[Docket No. FAA–2023–0672; Project Identifier AD–2022–01429–T]

Airworthiness Directives; The Boeing Company Airplanes

ACTION: Notice of proposed rulemaking (NPRM).

Figure 1 to paragraph (g)(2)(i)—*Fundamental Effective Isotropic PSD at Outside Interface of Aircraft Antenna*

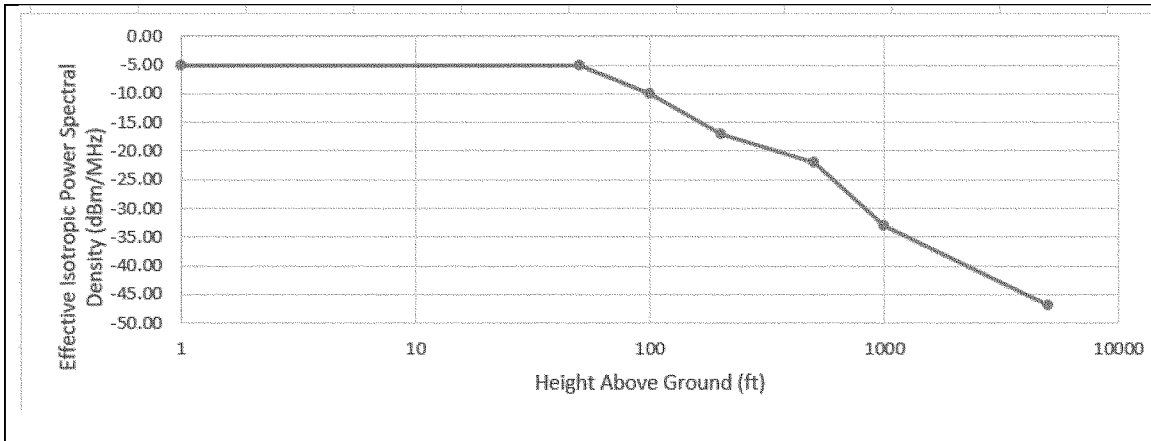
(i) Tolerance to radio altimeter interference, for the fundamental emissions (3.7–3.98 GHz), at or above the power spectral density (PSD) curve threshold specified in figure 1 to paragraph (g)(2)(i) of this AD.

Height above ground (ft)	Effective Isotropic PSD (dBm/MHz)
Aircraft on the ground	-5
50	-5
100	-10
200	-17
500	-22
1000	-33
5000	-47

Figure 2 to paragraph (g)(2)(ii)—*Spurious Effective Isotropic PSD at Outside Interface of Aircraft Antenna*

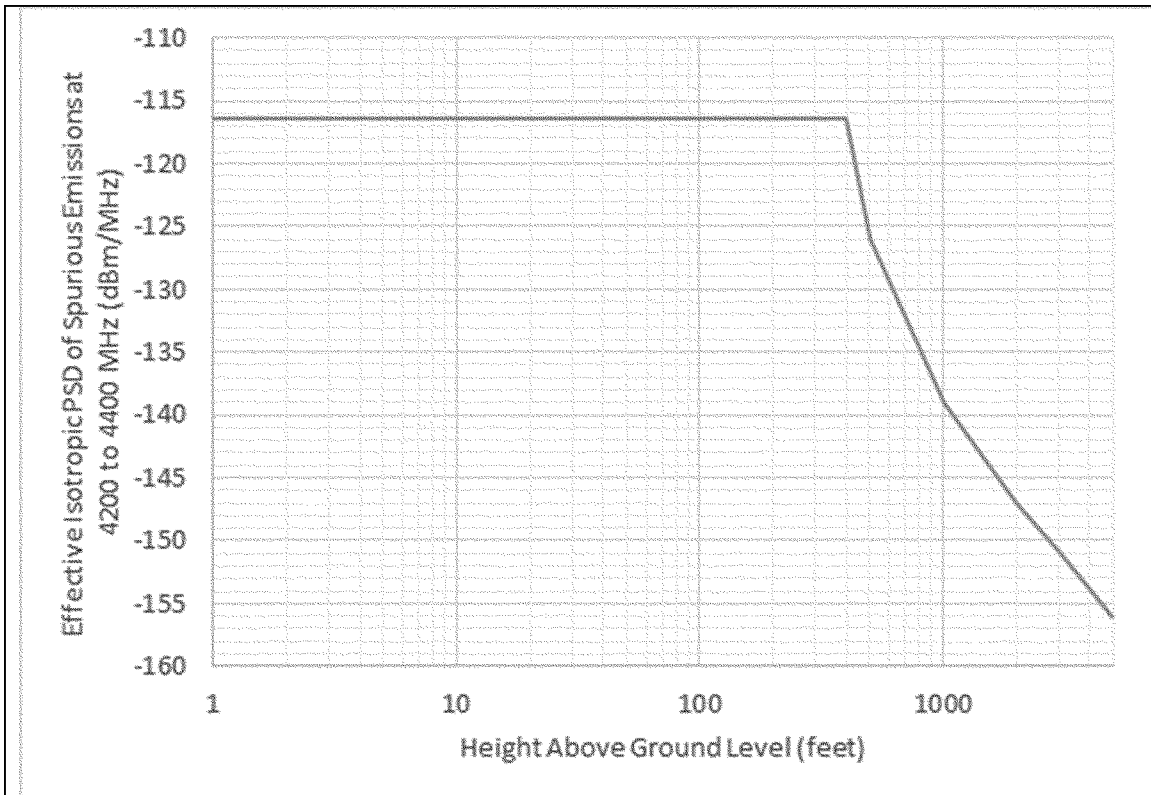
(ii) Tolerance to radio altimeter interference, for the spurious emissions (4.2–4.4 GHz), at or above the PSD curve threshold

specified in figure 2 to paragraph (g)(2)(ii) of this AD.

<u>Aircraft Altitude (ft AGL)</u>	<u>Effective Isotropic PSD (dBm/MHz)</u>
1	-116.50
400	-116.50
500	-126.00
1000	-139.00
2000	-147.00
3000	-151.00
5000	-156.00
